Energy Users Coalition of Victoria

Victorian Electricity Transmission Revenue Reset

AER Draft Decision and SP AusNet Revised Application

A response

Figure 11.1 – Future Real Price Path for SP AusNet (\$/MWh)

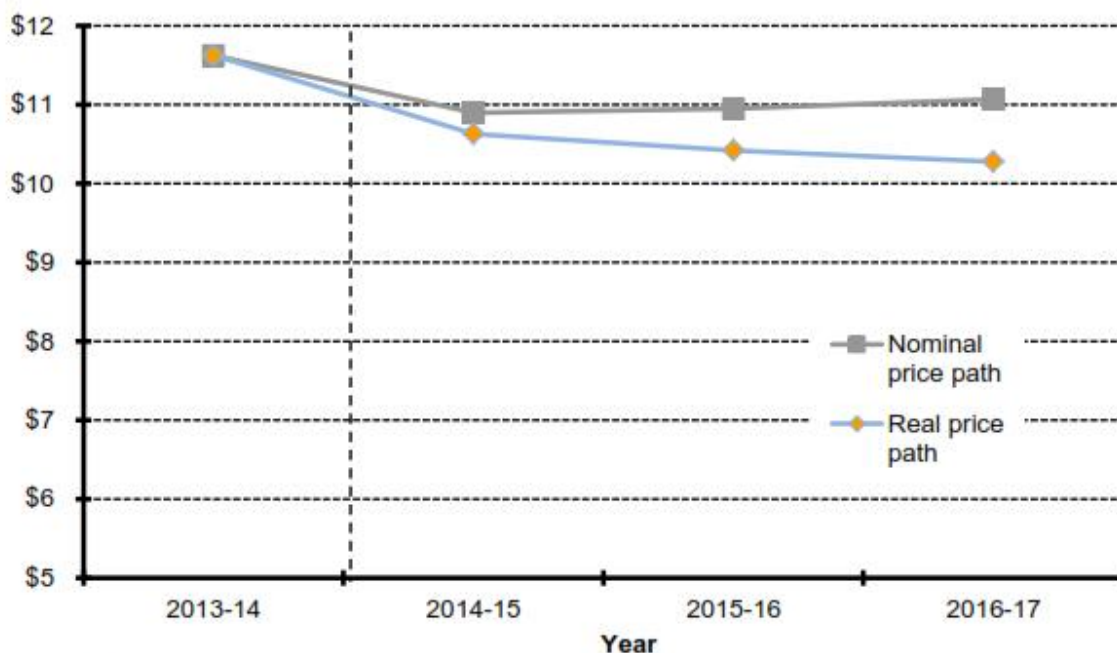
The only positive outcome from the revised application is that SPA forecasts that the average tariff for electricity transmission services will fall from the levels seen in AA3 to lower levels. This is shown in figure 11.1 in the SPA revised application².

² It is important to note that the consumption forecasts that underpin these future average prices incorporate an annual growth of 1.3% pa despite falls in recent years showing an increasing annual reduction in consumption.

The outcome of the revised application is that SPA is likely to continue to be the second least expensive TNSP in the NEM - this is despite SPA not having to include the cost of augmentations provided by AEMO under its role as the Victorian transmission operator and Victoria having a much denser consumption than TransGrid which has the lowest overall unit costs.

Figure 11.5 Spreads on long dated bonds

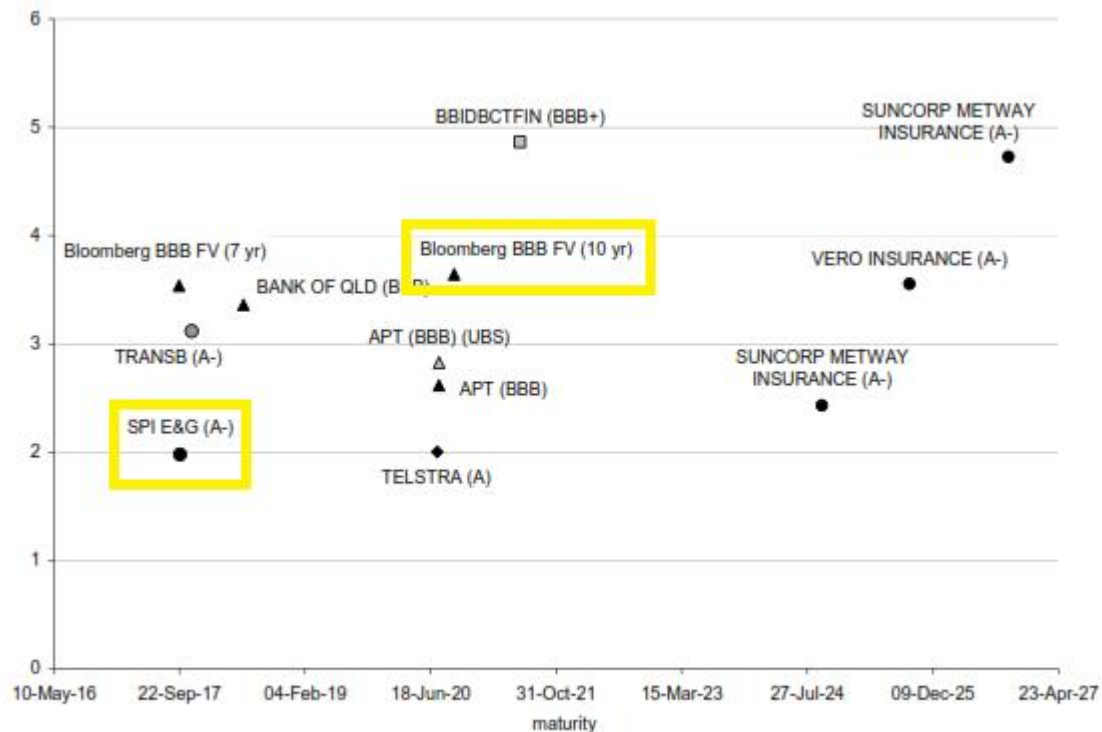
The following figure was included in the AER final decision (page 508).

The empirical observations confirm this assessment where the BFV for 10 year BBB rated debt is higher than the actual cost of debt secured by BBB rated APT and of SPI/SPA itself (see figure 11.5 above)

The clear import of the recognizing that the lower the risk of the industry a borrower operates in, is that the firm will pay a lower cost for its debt. The figure 11.5 above shows that regulated firms (such as SPI, APT and Telstra) will incur debt costs below the average experienced by firms with the same credit rating.

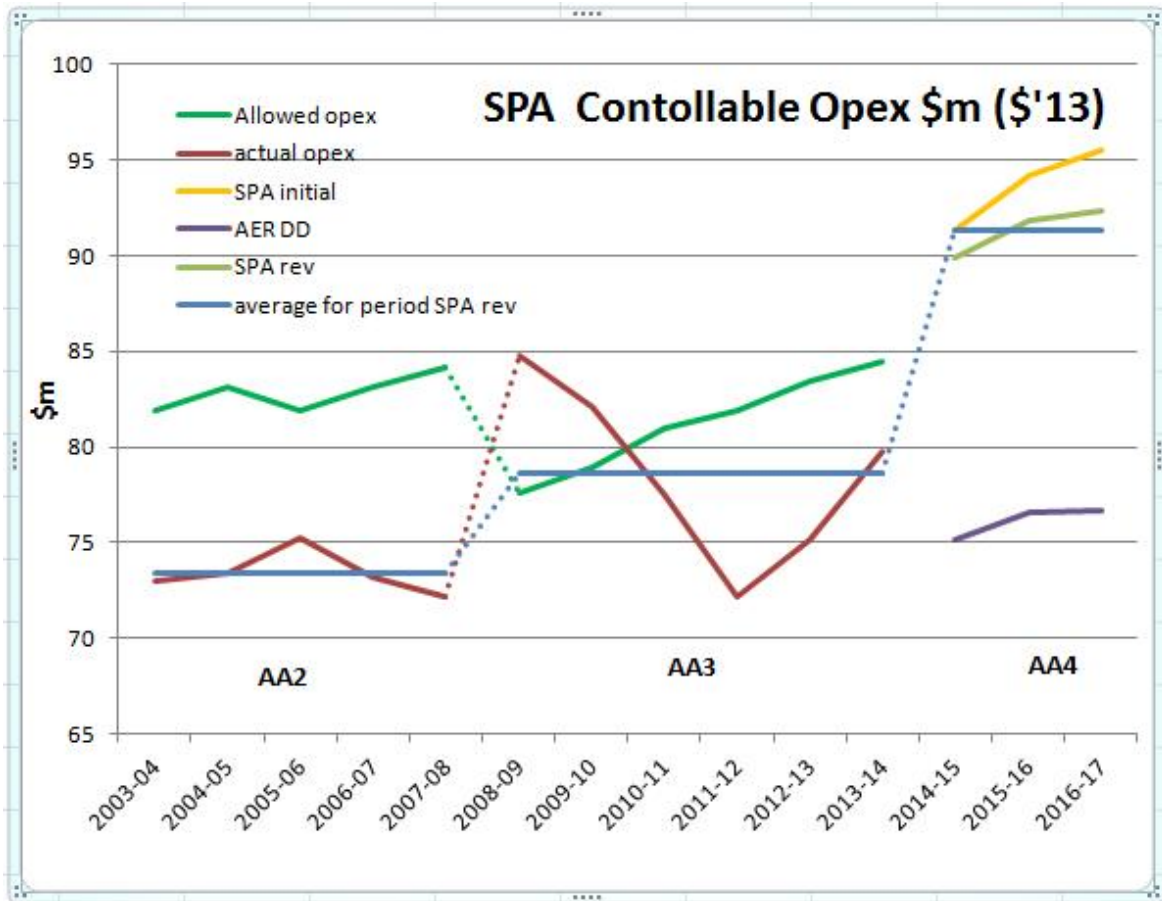
The following chart showing controllable opex has been developed from data in SPA applications 2002, 2007 and 2013 (initial and revised) and the AER draft decision.

Basically this chart shows that SPA has marginally reduced its claim for controllable opex for AA4 by about \$2m pa to an average of about \$92m pa following its review of the AER draft decision.

In contrast, the AER draft decision indicated that controllable opex should be quite similar (in real terms) to the opex SPA had incurred during the later years of AA3. The difference between the AER opex allowance and the SPA revised opex in terms of costs to consumers, adds some \$0.30/MWh or nearly 3.5% to the total cost of the service to consumers. This marked difference is concerning.

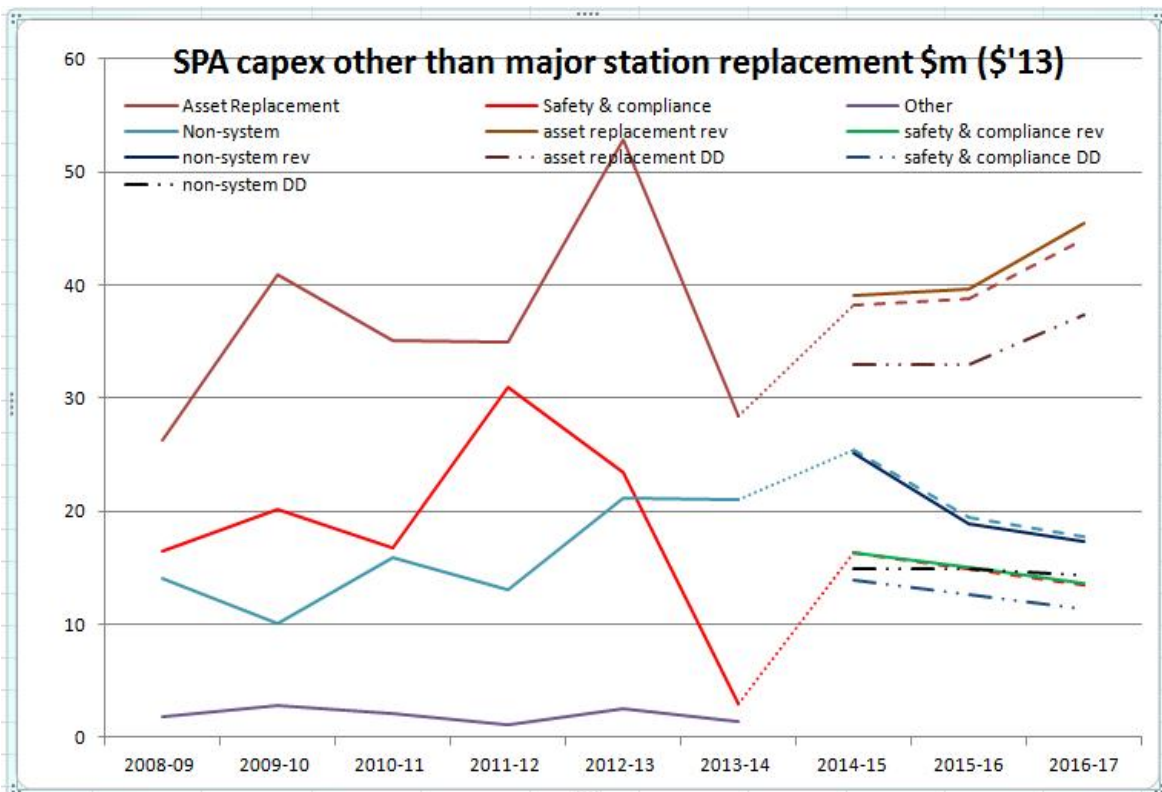
SPA capex for the Victorian transmission system is graphically presented in the following chart which spans regulatory periods AA1, AA2, AA3 and the forecast AA4. The chart shows the actual capex, the SPA initial forecast for AA4 and the SPA revised forecast for AA4. The average actual capex for each period is also shown (including the revised forecast average) as is the ACCC/AER allowances for capex and the AER draft decision on capex for AA4.

This highlights that the initially proposed capex for period AA4 is quite excessive when seen in context with the capex incurred in periods AA2 and AA3. The revised forecast capex is only marginally lower than that initially proposed by SPA in its initial application, despite the AER draft decision implying that capex levels similar to that experienced in AA3 would be appropriate.

What the chart also shows is that in AA3, SPA was allowed considerably more capex than was actually used, and this provided SPA with a significant benefit which it can retain. In this regard, if the guidelines developed for the Better
